SUBJECT: Responds to NRC 830608 telecopy requesting clarification of
 three areas of util preservice insp program. Clarification of
 preservice insp of scram discharge vol sys encl.

Subject: NUCLEAR PROJECT NO. 2
PSI SUMMARY REPORT CLARIFICATION

Reference: Telecopy, A. Schwencer (NRC) to R. Nelson (SS),
6/8/83 "Washington Public Power Supply System,
Washington Nuclear Project No. 2, Review of
the Preservice Inspection Program"

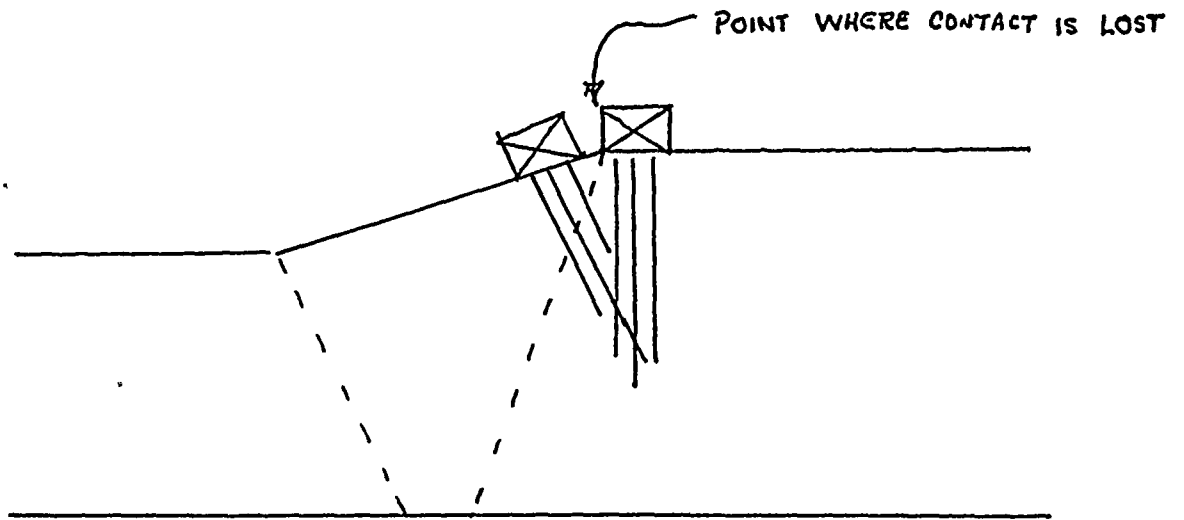
As described in the WNP-2 PSI Summary Report, contact between the ultrasonic transducer and the reactor pressure vessel wall was maintained approximately 75% of the time on the transition from the first to second shell course. This statement should not be construed to mean that the volume of material specified to be examined by ASME Section XI was not examined. To the contrary, the Supply System feels that a full code examination was performed. NES, Inc. performed this examination manually as described on pages 3, 4 and 5 of the WNP-2 PSI Summary Report. The LMT examination demonstrated that the mechanized equipment would produce results which are essentially the same as a manual examination. Regardless of whether a mechanized or manual examination is performed, a 100% examination is still achievable. This is because the examination is performed from the outside diameter of the vessel and from both directions, above and below the weld. Because of the slope, as shown below, the coverage overlaps.

The above illustration is for a 0° examination. For the 45° and 60° shear wave examinations, the transducer would not need to ride over this transition to gain full coverage of the required weld volume.
